## 4 Masterplan & Public Realm

# 6 Comparison Drawings

The following pages contain a series of comparison drawings to allow the amended design changes to be reviewed directly alongside the original approved planning drawings.

#### 4.7 'The Square' & Events

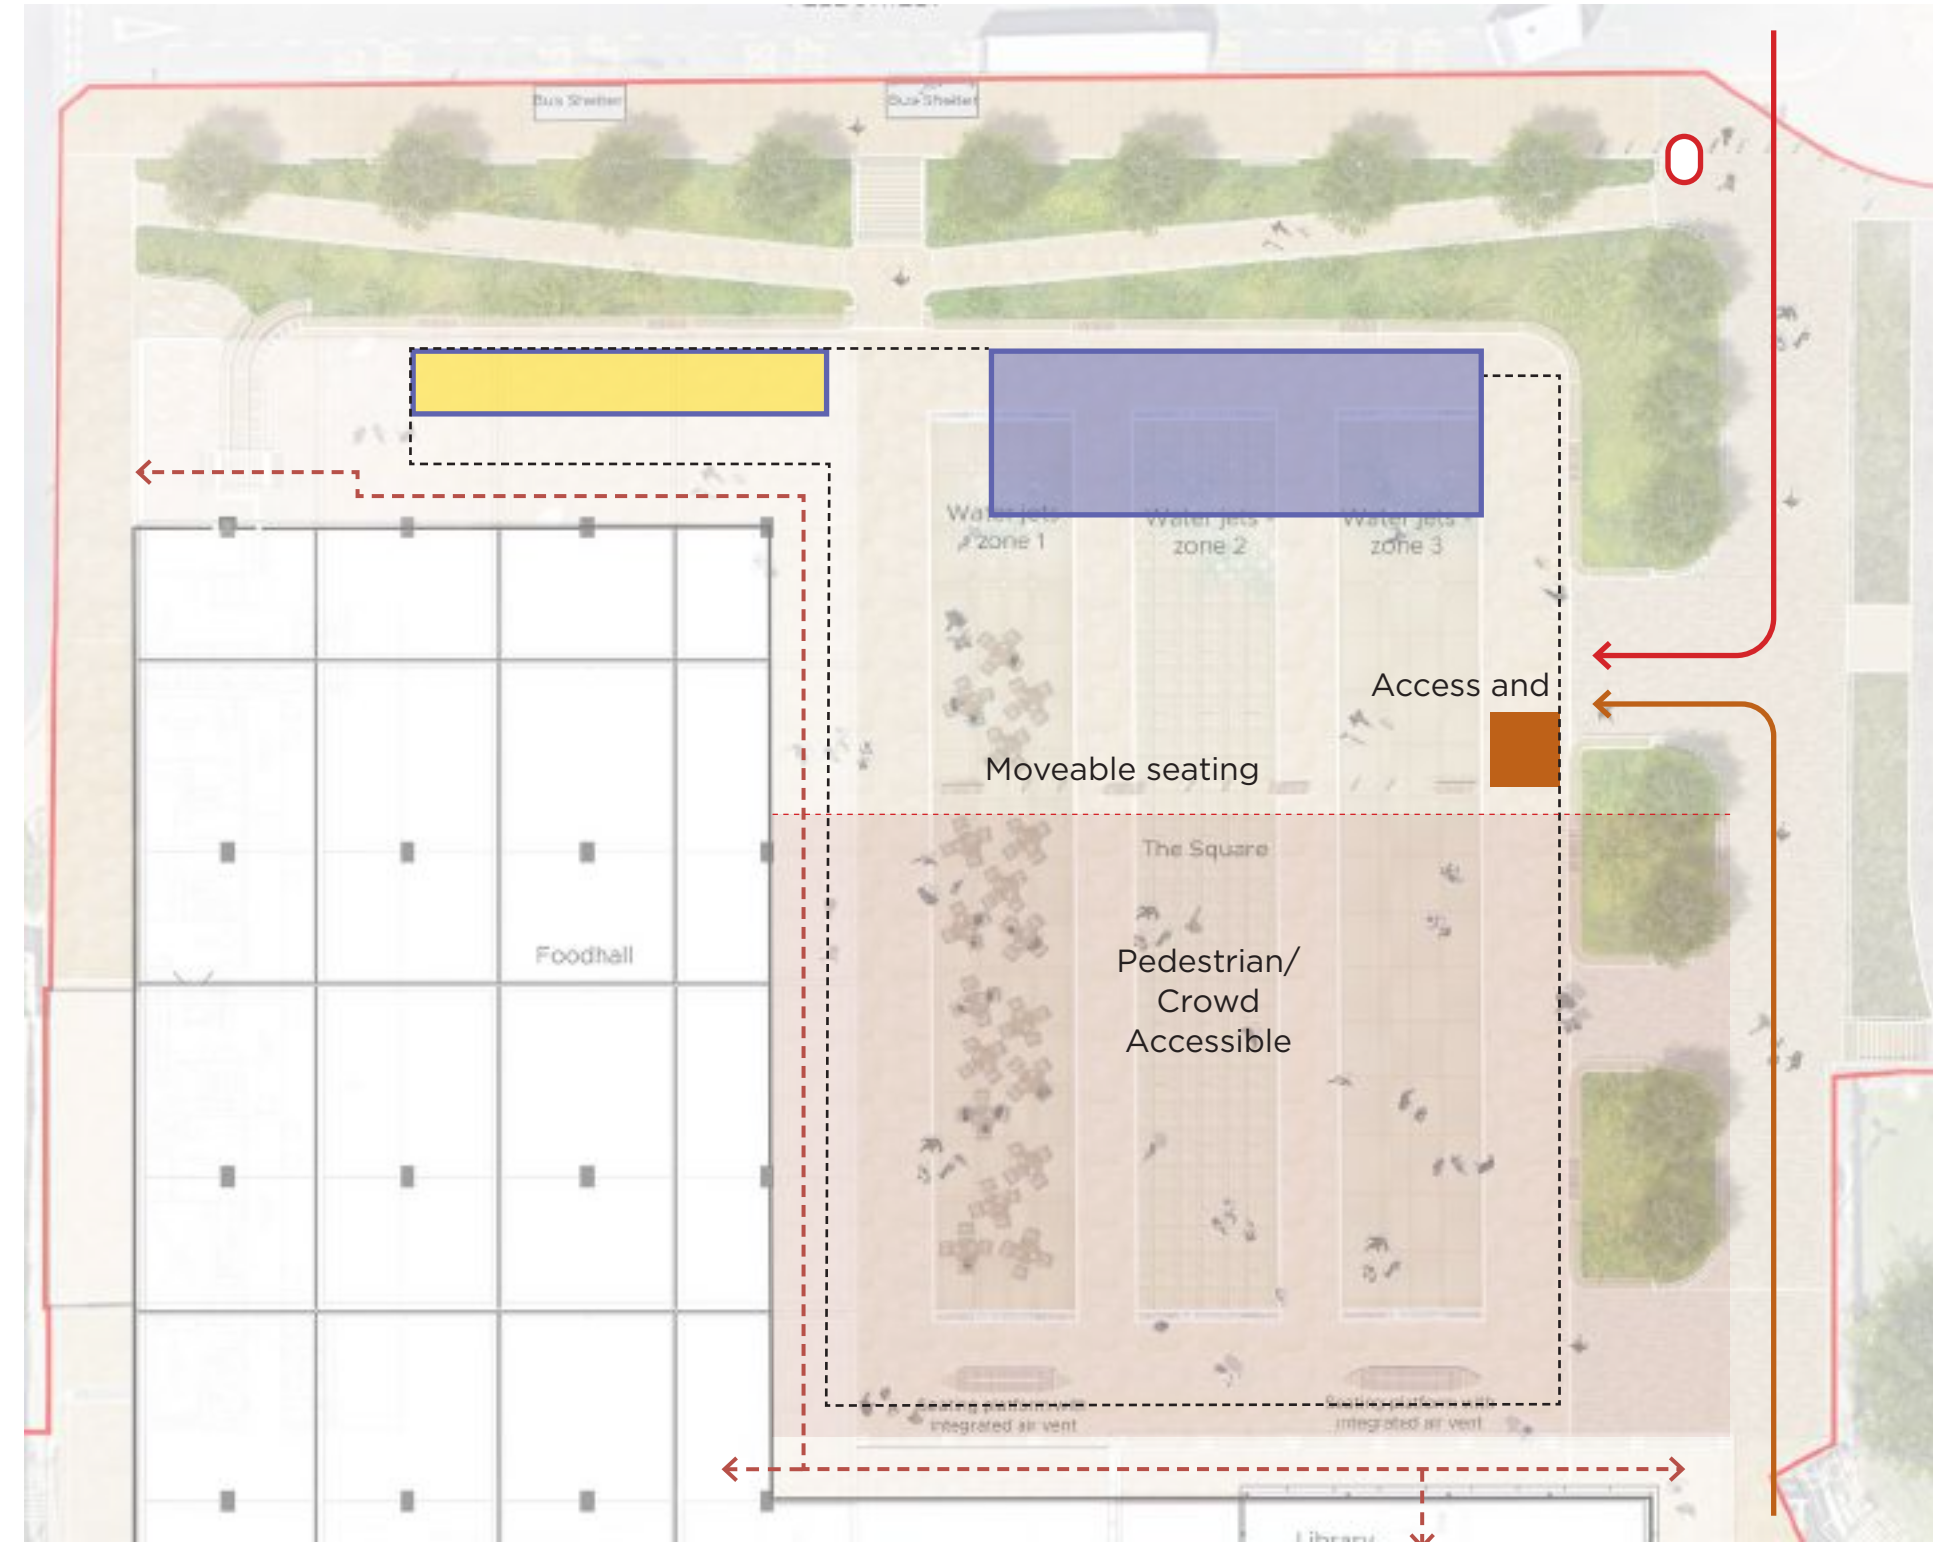
There are loading restrictions placed on the events space due to the basement slab now being retained rather than replaced. The red tone to the square delineated by a red dashed line indicates this area of loading capacity restrictions. This is demarcated through the use of semi-permanent moveable benches, which would only be removed once all vehicles have moved from the space.

It is confirmed that a stage and ice rink would need to sit in the top half of the square where there aren't any loading implications and that only crowds should occupy the space

#### 4.8 Vehicular Site Access and Maintenance

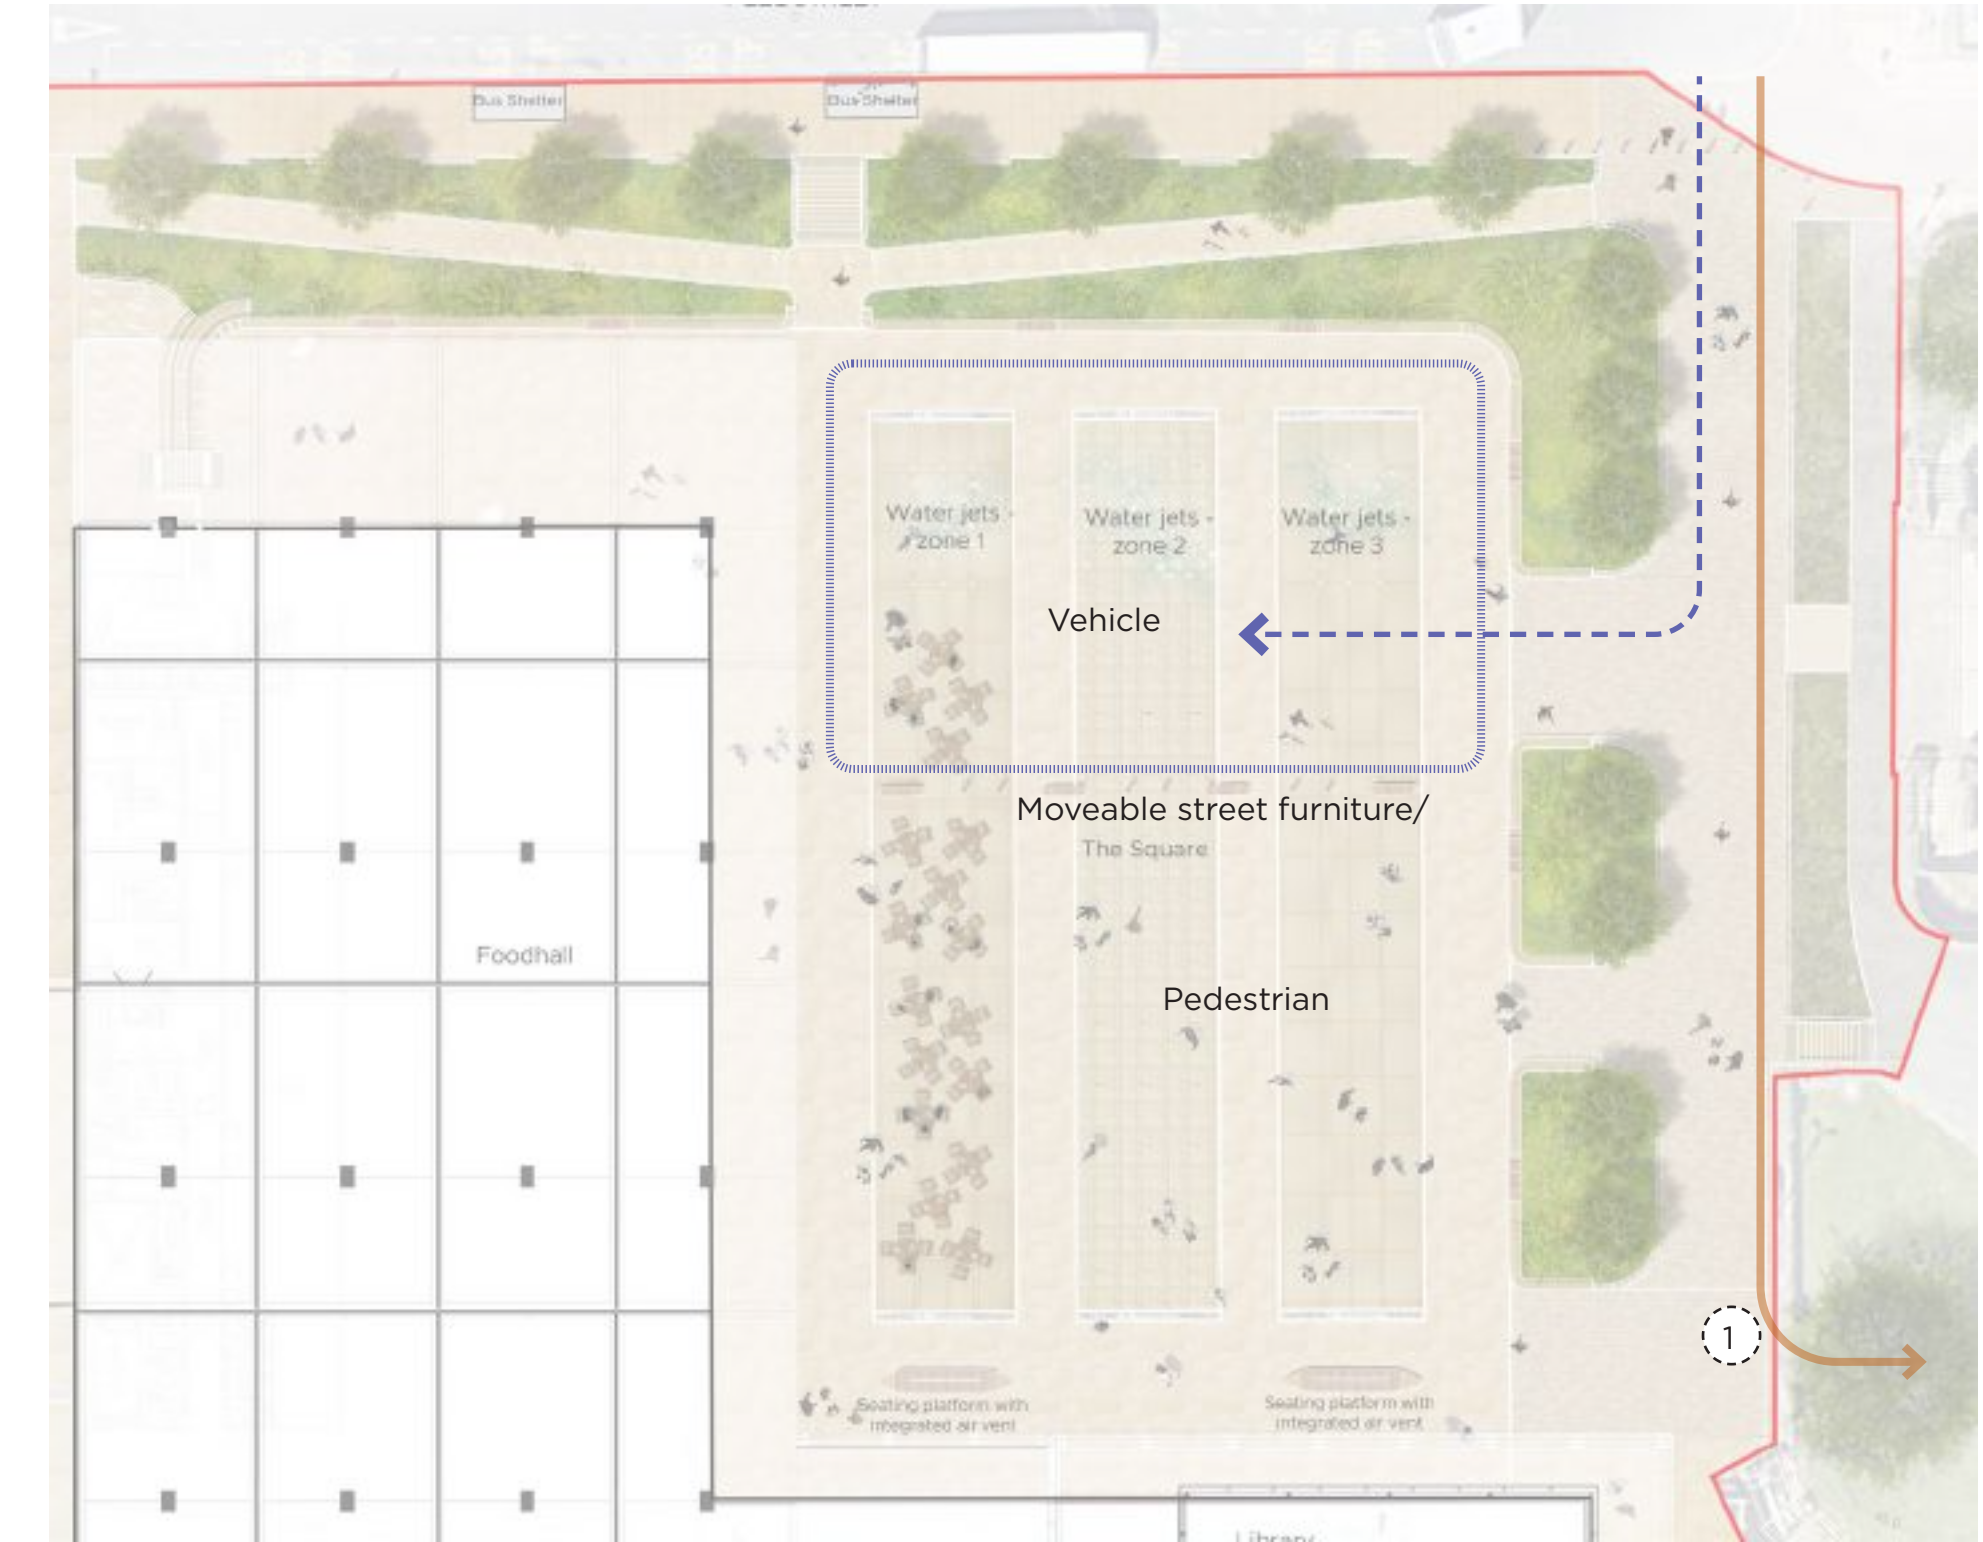
Future maintenance access to the wider masterplan for large vehicles is suggested to follow the route as indicated. Due to the basement slab retention, it is suggested that a small amount of re-design may be required at the corner marked '1'. This would still work mostly with the existing design, however, would need to ensure that vehicle overrun does not occur over the basement slab.
